Subject: **Bid No. 8800-M7 – Accessibility Renovations – New Citizen Center / WPS**

ADDENDUM NO. 3

**1407A MAIN STREET
WORCESTER, MA 01603**

FINISH PLANS & DETAILS

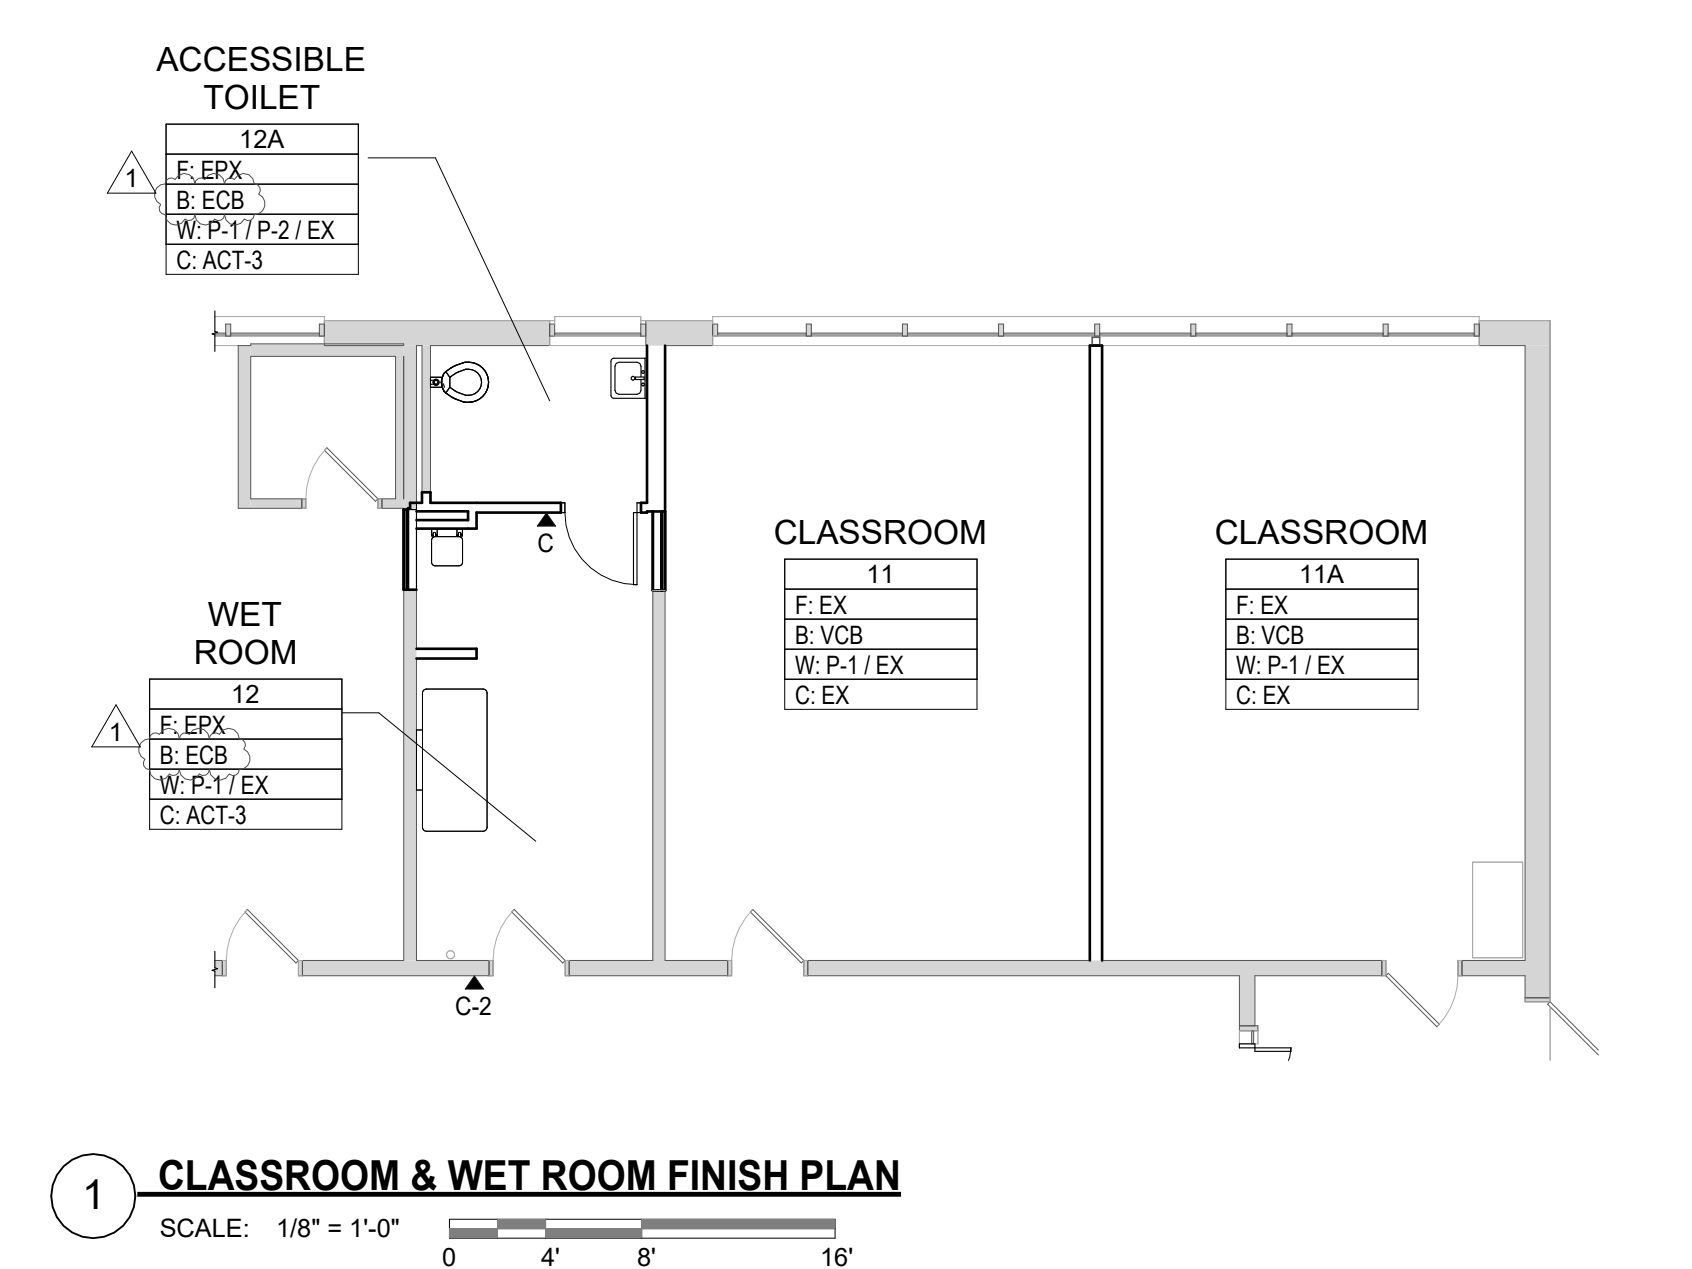
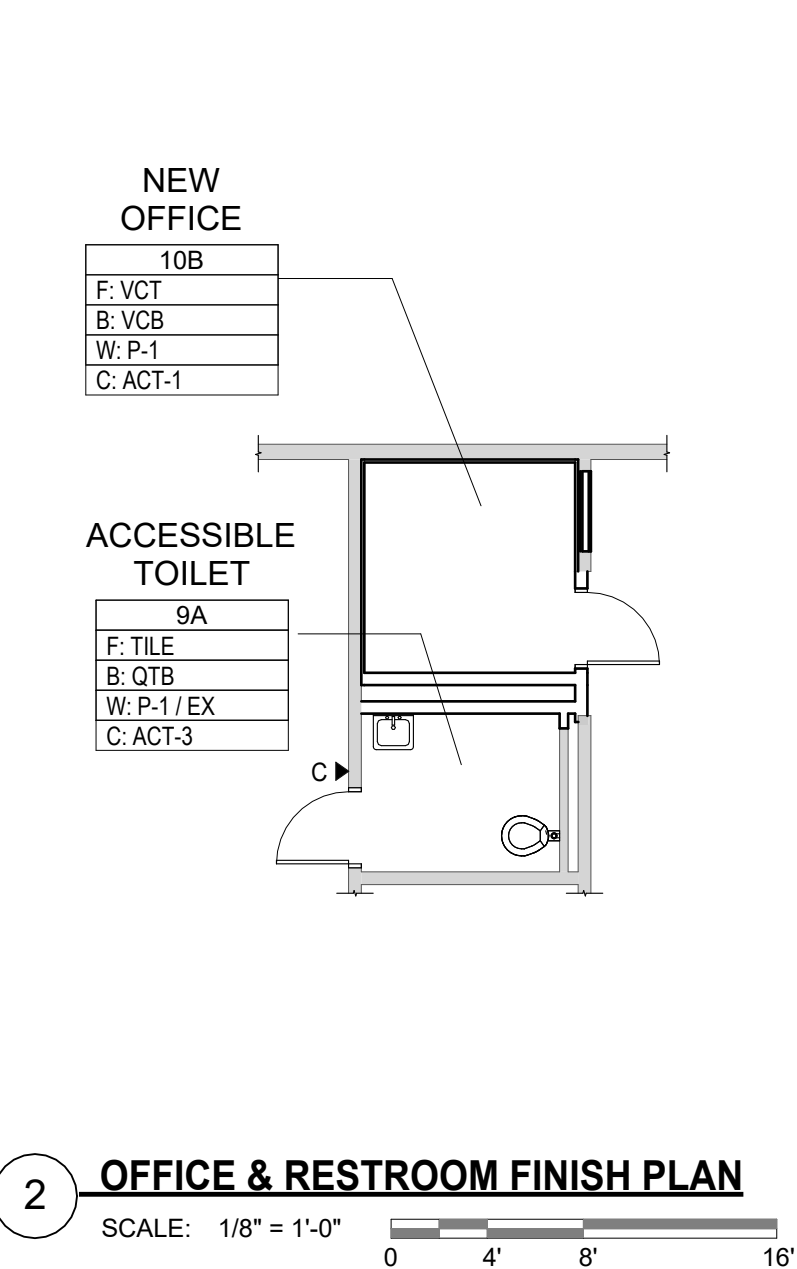
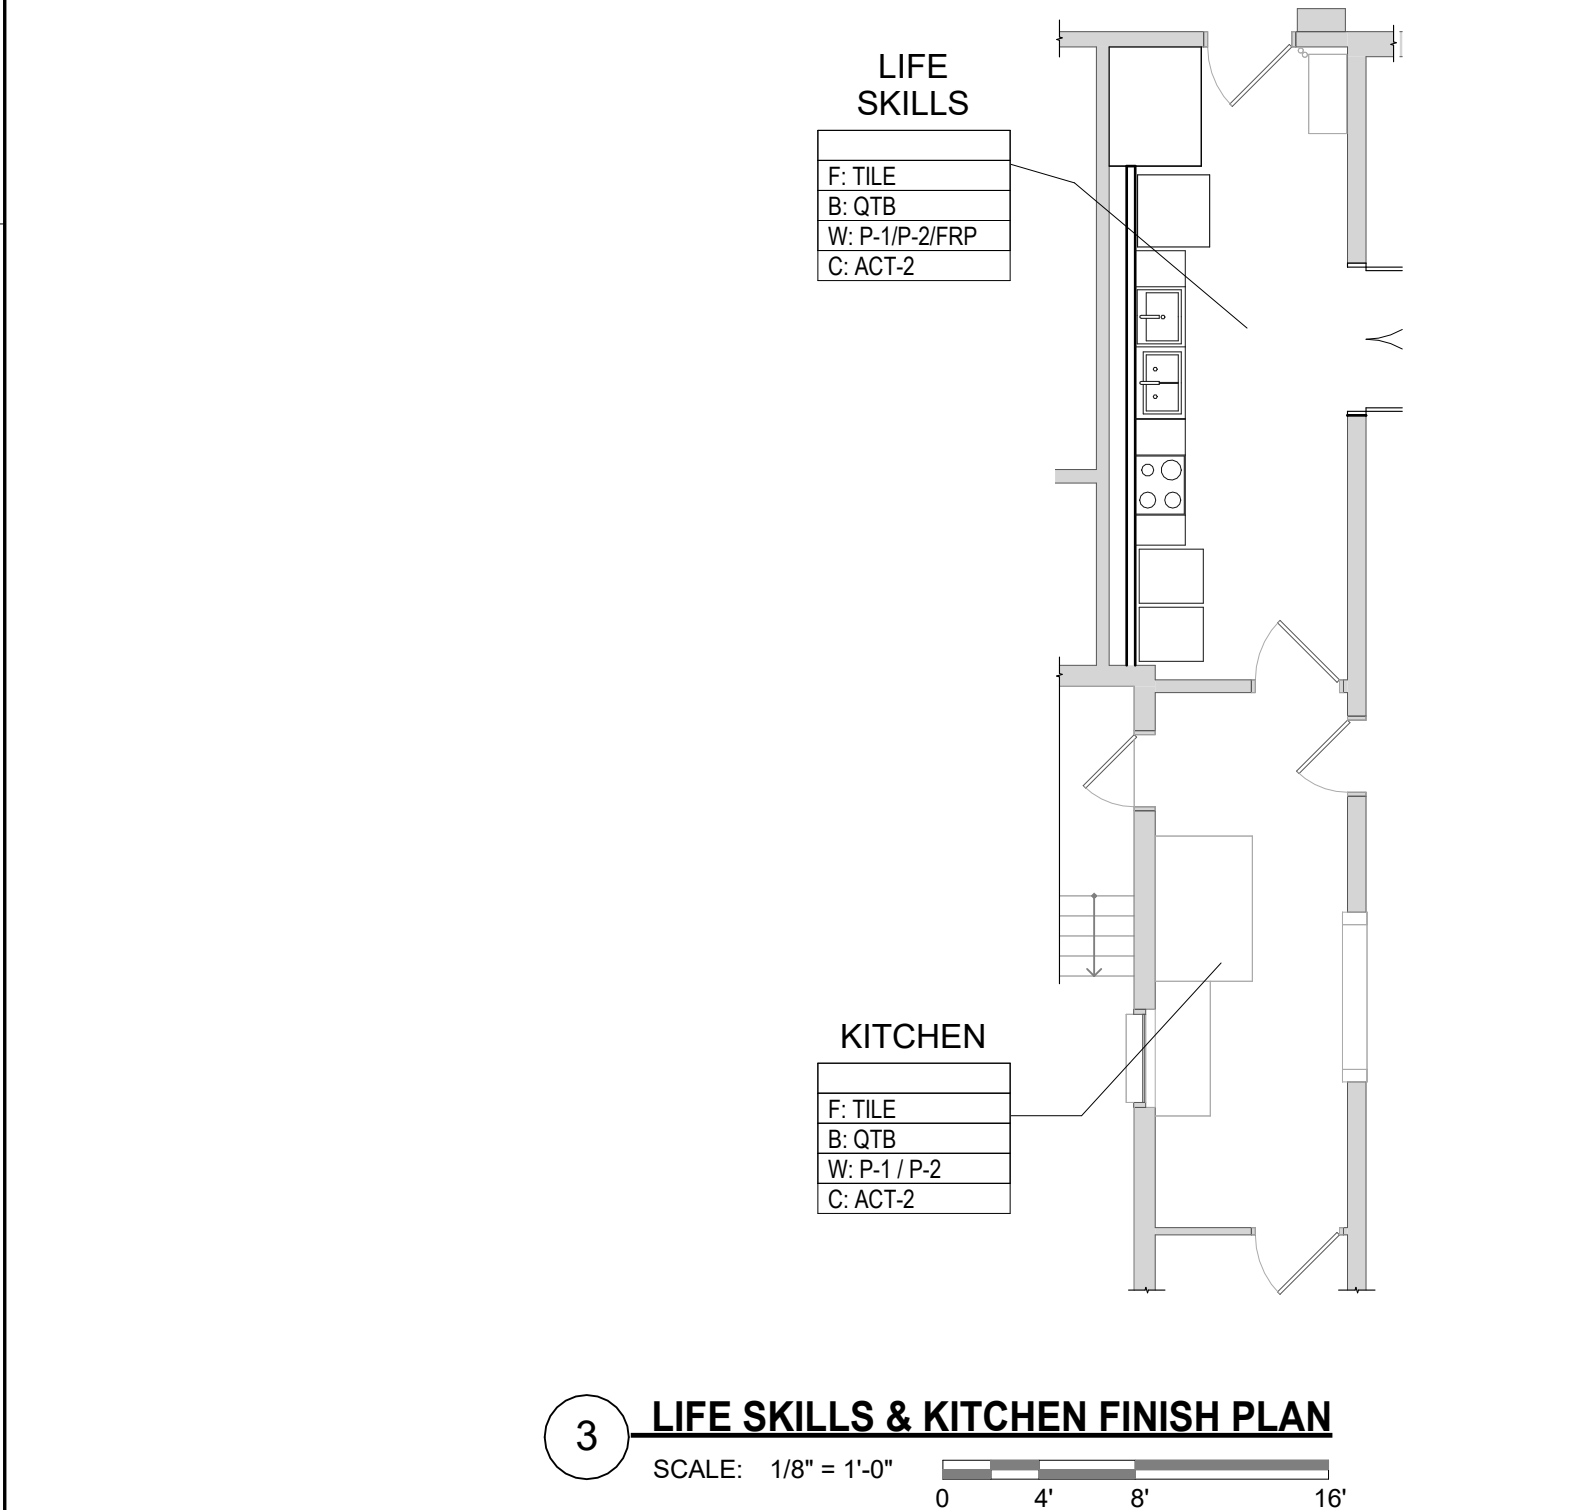
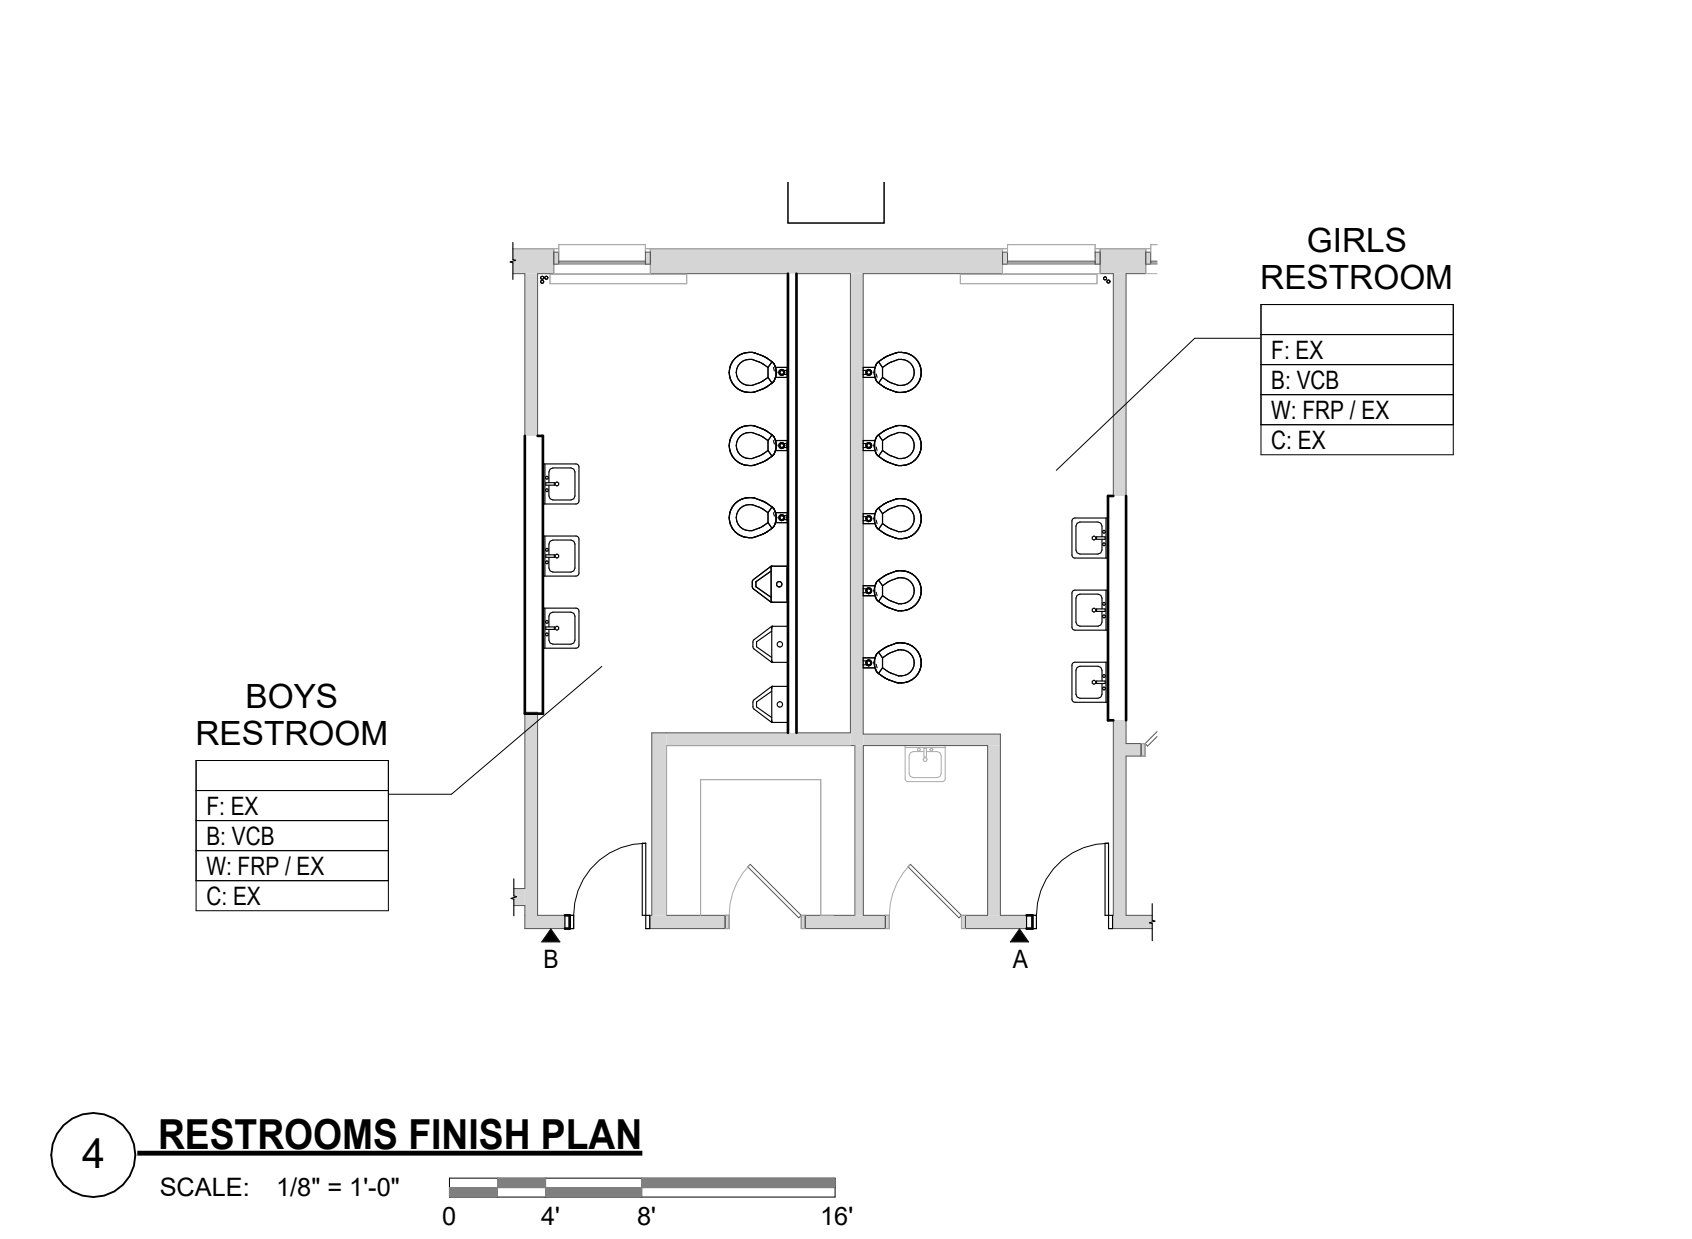
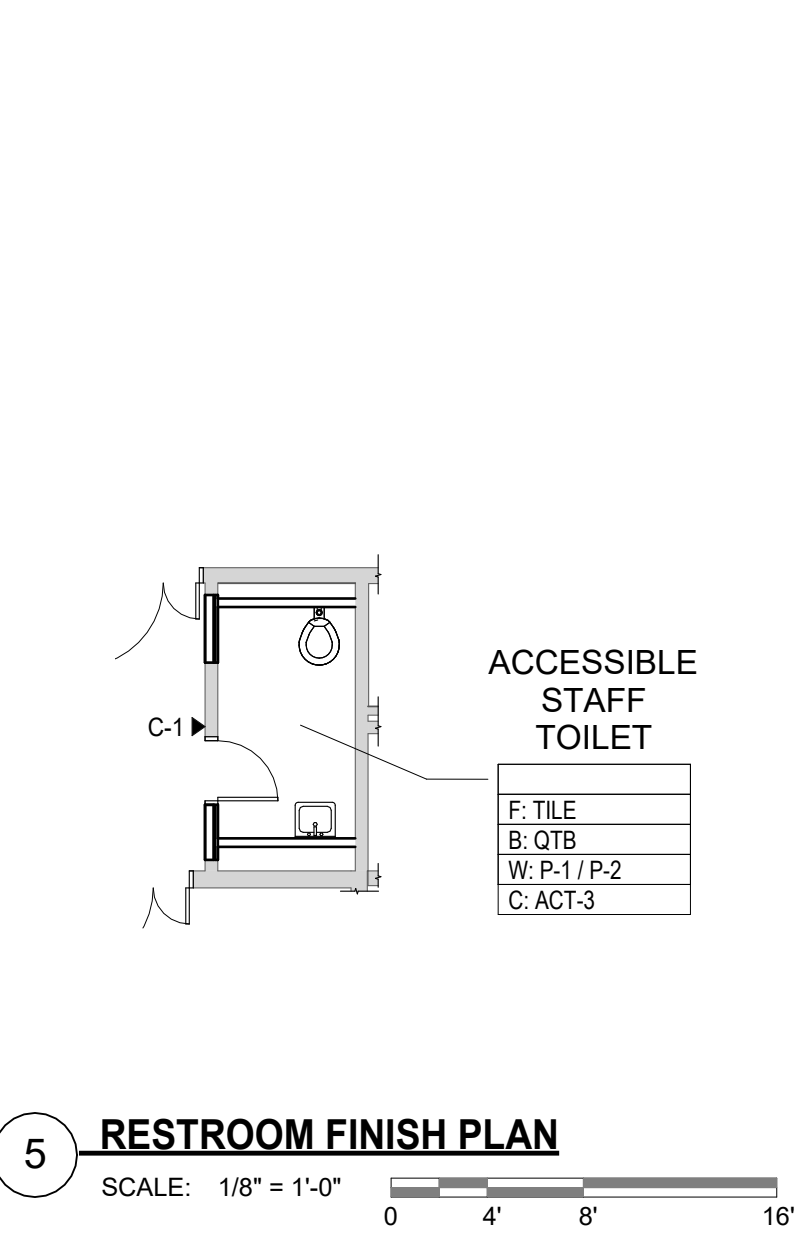
Answer:	Will be answered in future Addendum
Question:	clarify whether Rooms 12 and 12A receive the vinyl base shown on A-710 or the specified 6-inch integral resinous base.

Answer:	Rooms 12 and 12A to receive integral epoxy cove base.
From:	Poulin Construction
Question:	Need clarification on Adult changing station, make and model perhaps Also same question for the shower seat, make and model
